ADDENDUM NO. 1
BASEBALL AND SOFTBALL COMPLEX RENEWAL
FOR GADSDEN STATE COMMUNITY COLLEGE
Architect Job No. 23-66
November 30, 2023
ACCS No. 2023 063 GSCC

The Plans and Specifications are hereby amended. The following supersedes all contrary and/or conflicting information and is made part of the contract documents.

C2.0

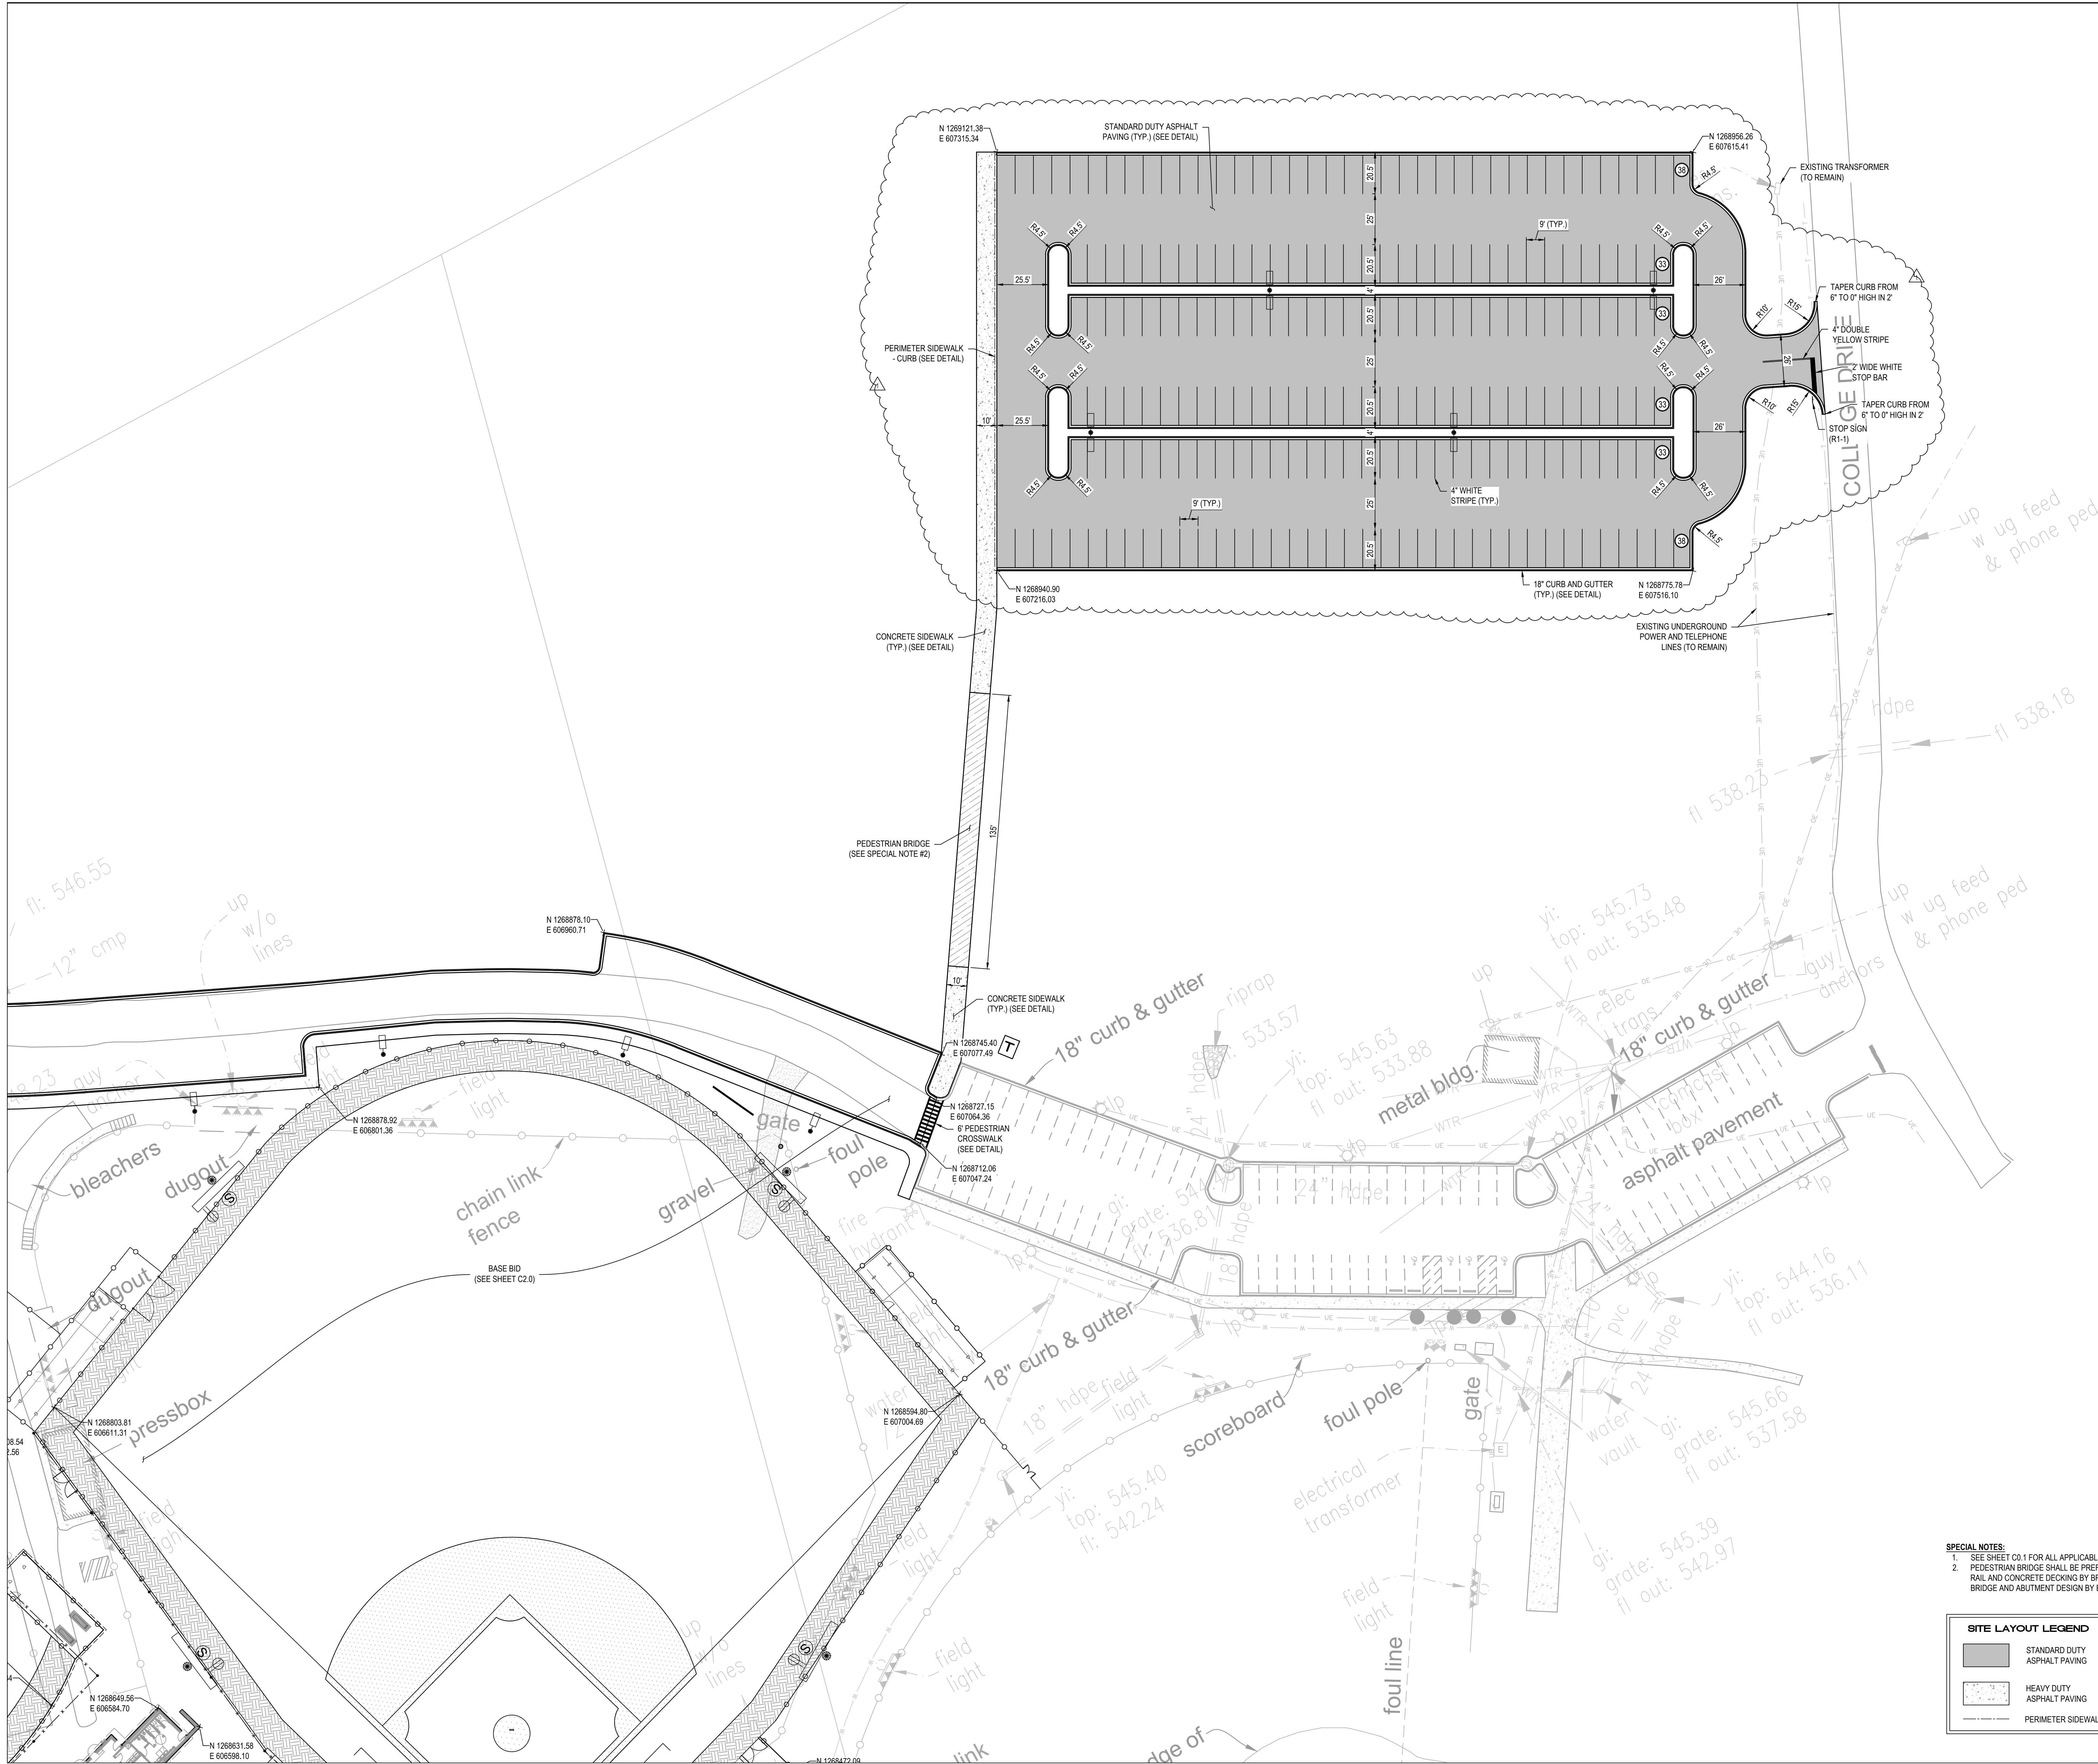
1. Sheet **C2.0** revised drive width to 25' per city comments. Added light pole locations and transformer pad locations.
2. Sheet **C2.1** revised drive widths to 25' per city comments.

C3.0

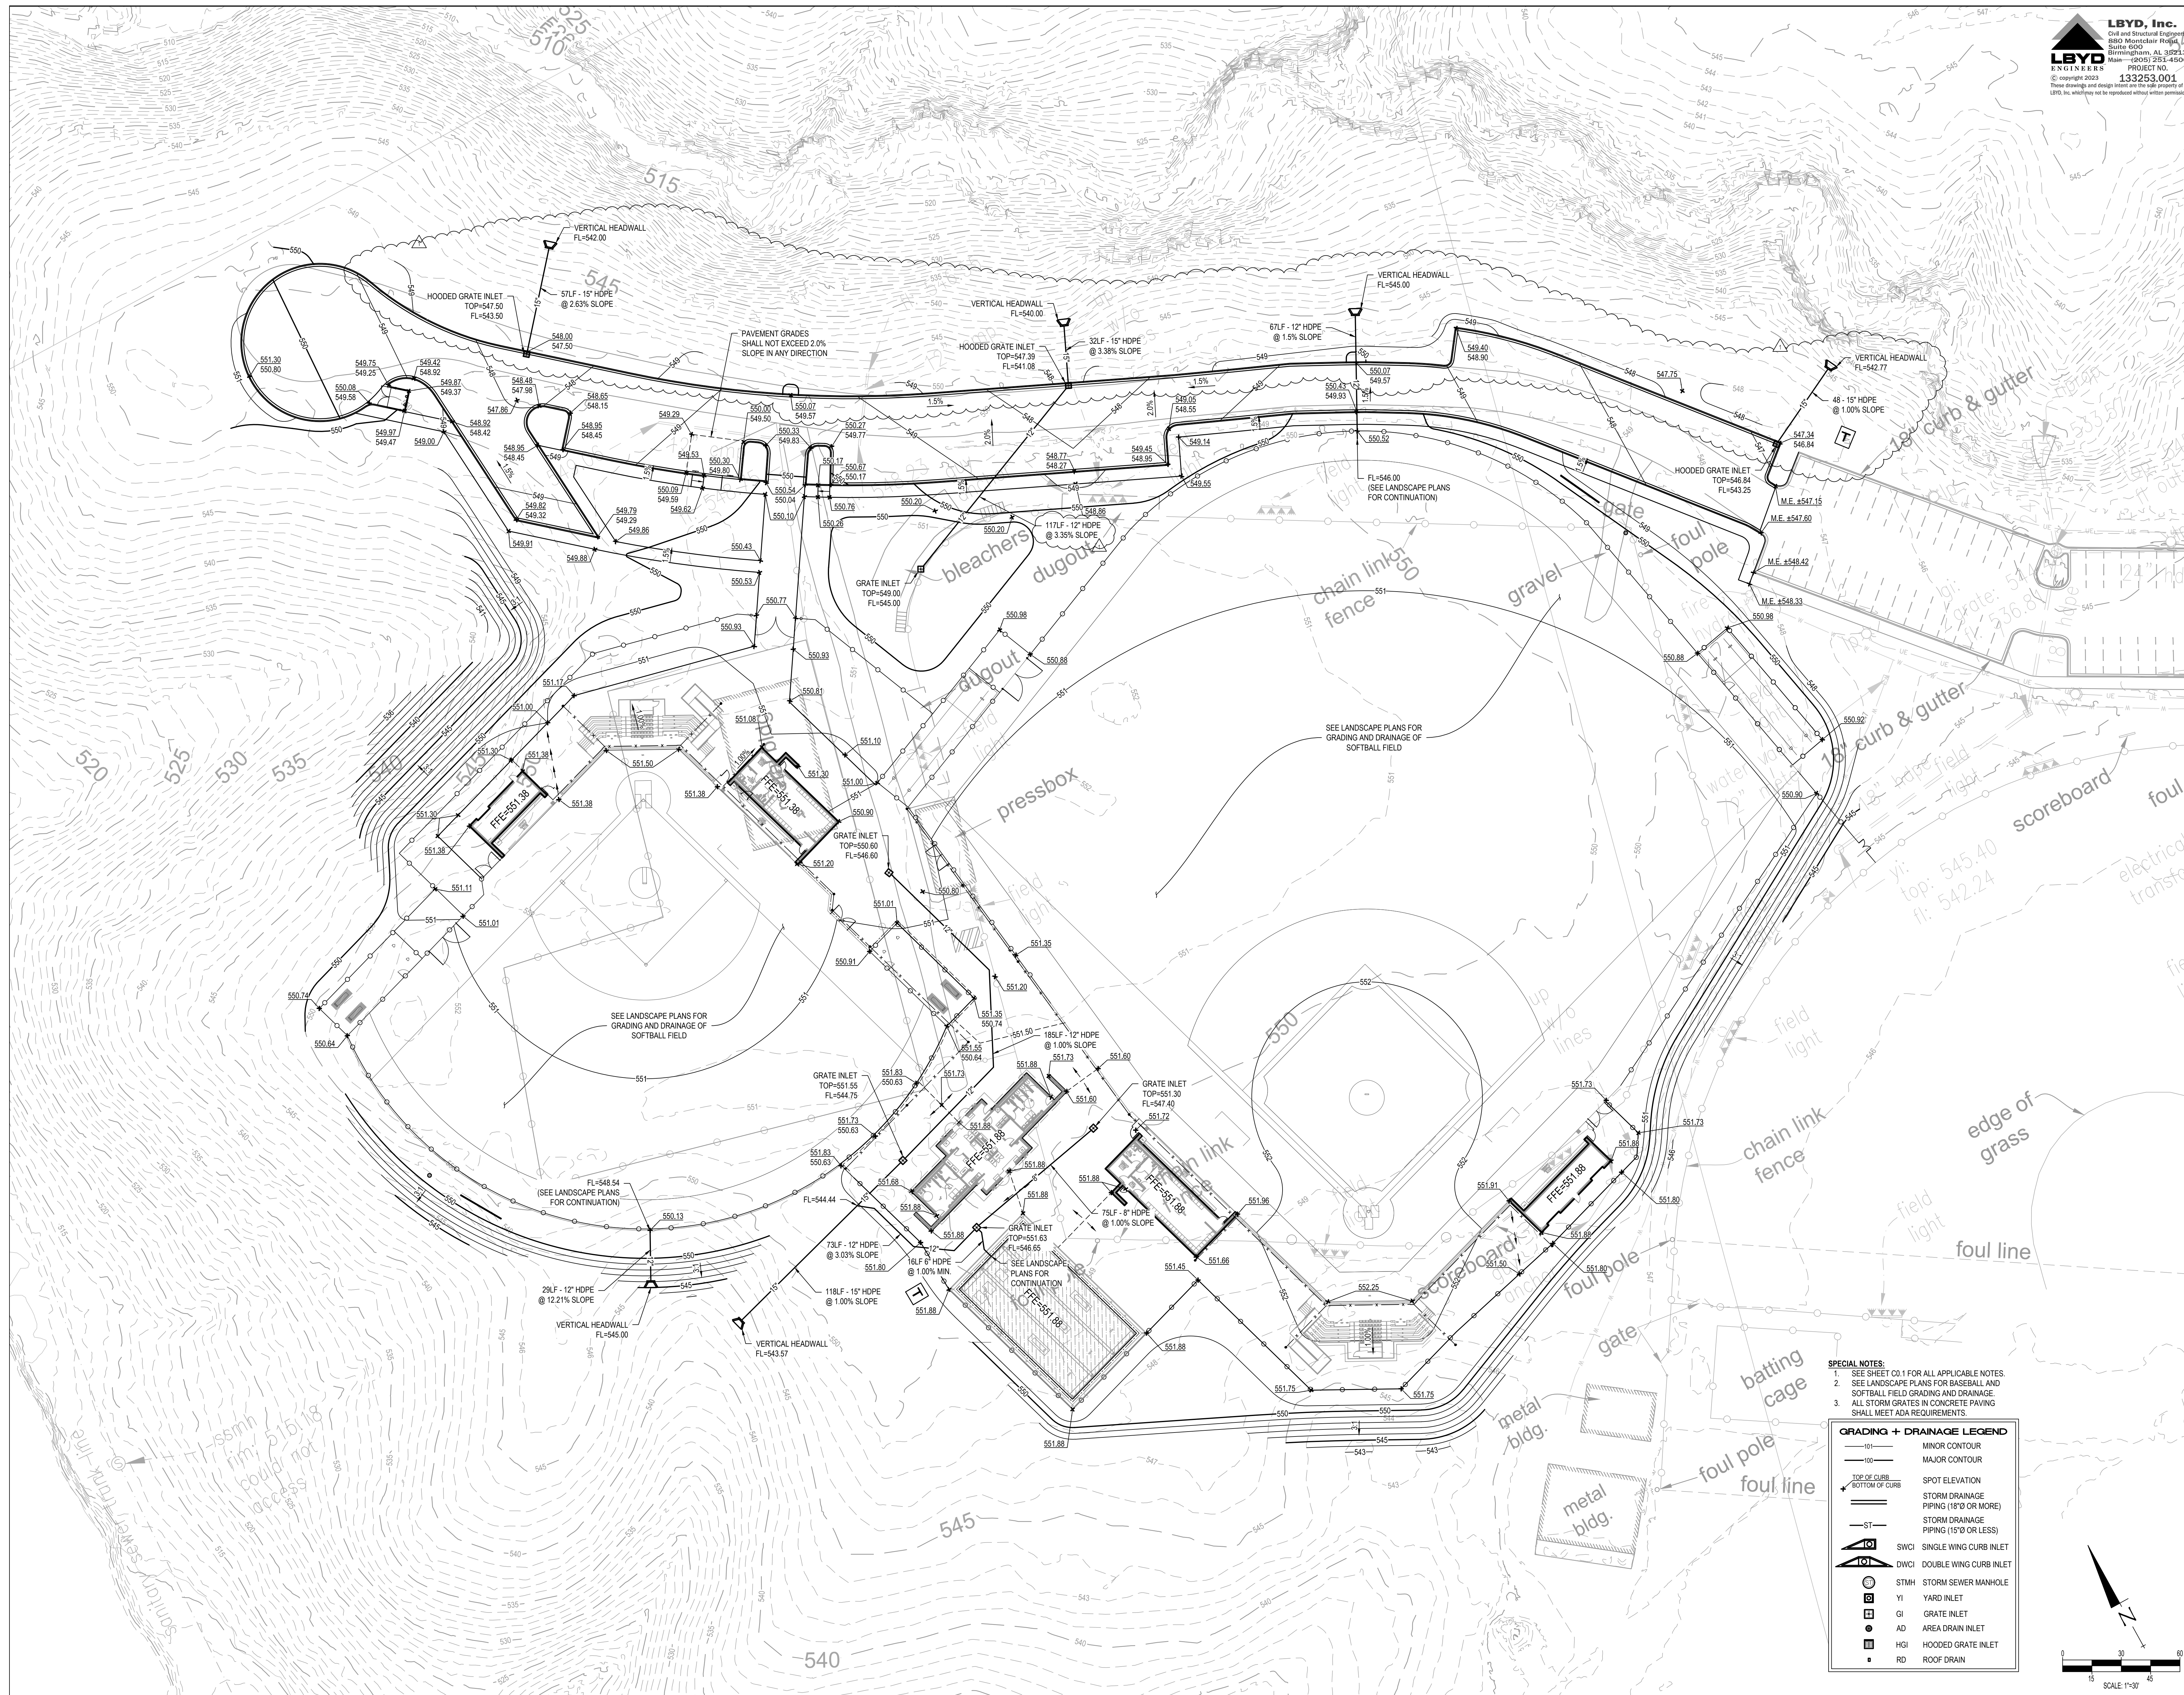
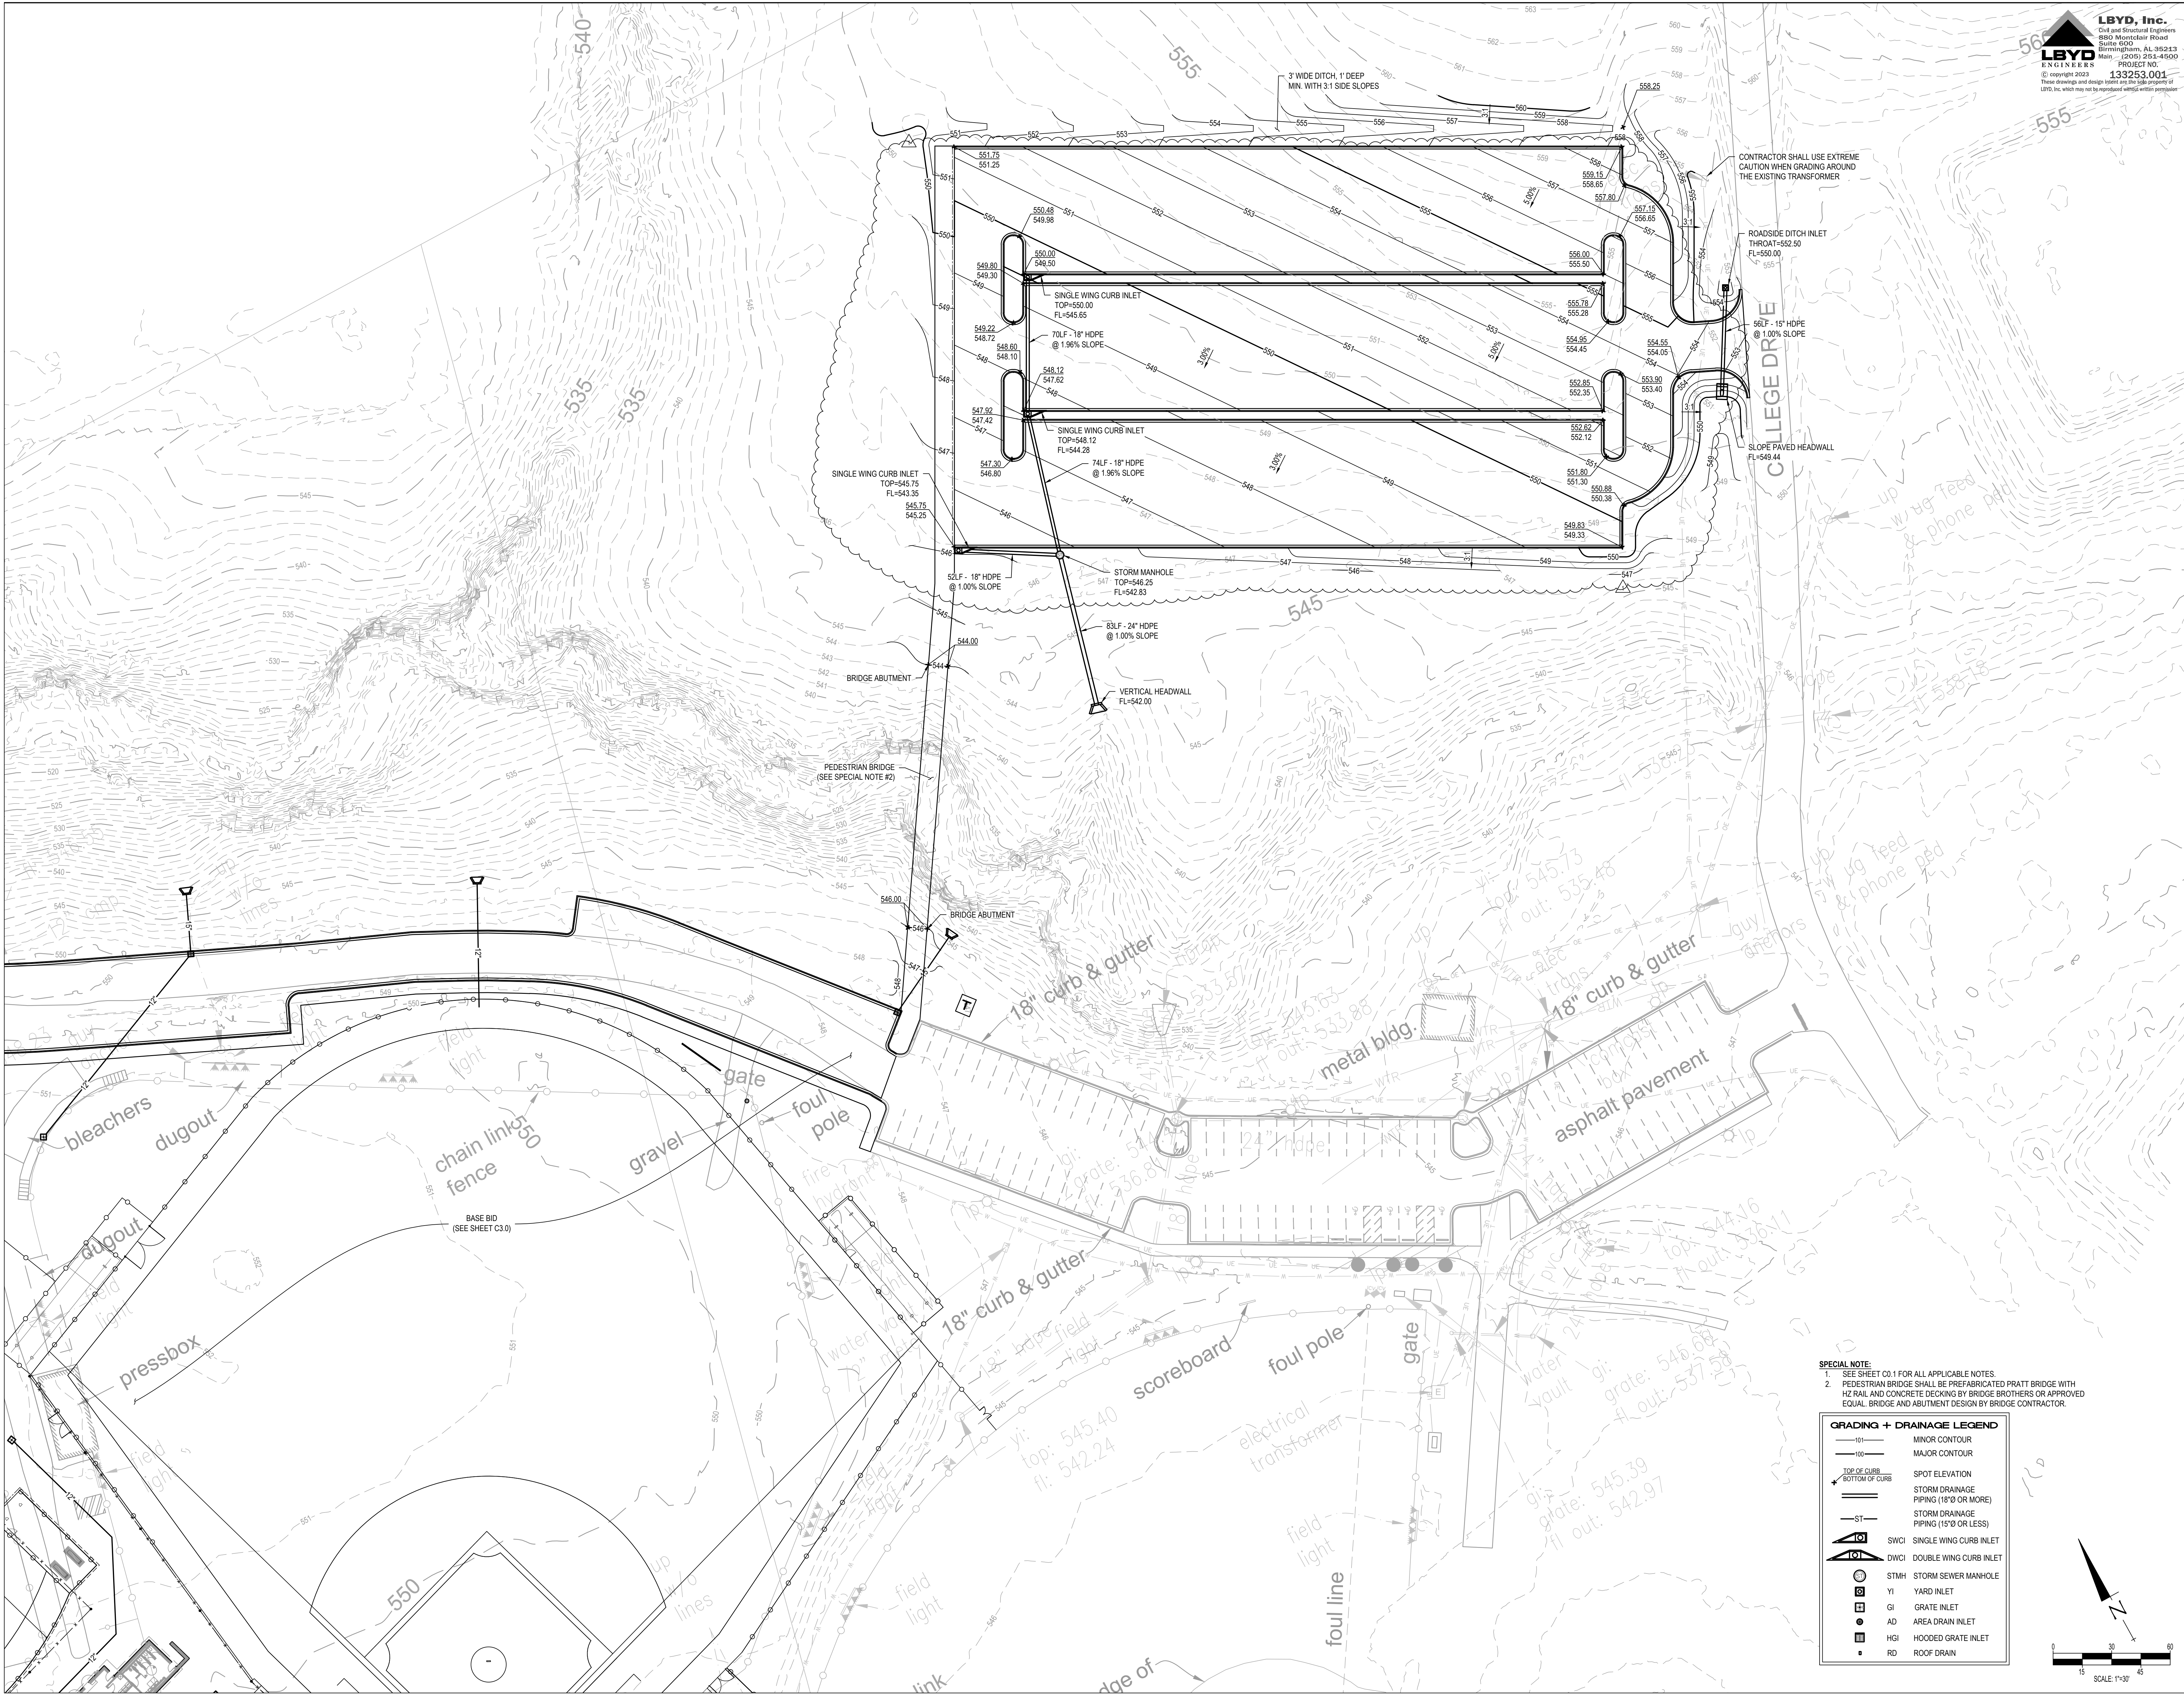
3. Sheet **C3.0** & Sheet **C3.1** revised grading to new drive widths.
4. Sheet **C5.0** added light pole and transformer pad locations.
5. See attached Sheet **E0.2**, **E0.5**, **E0.6**, **E1.0**, **E2.1**, & **E4.1** for revisions.
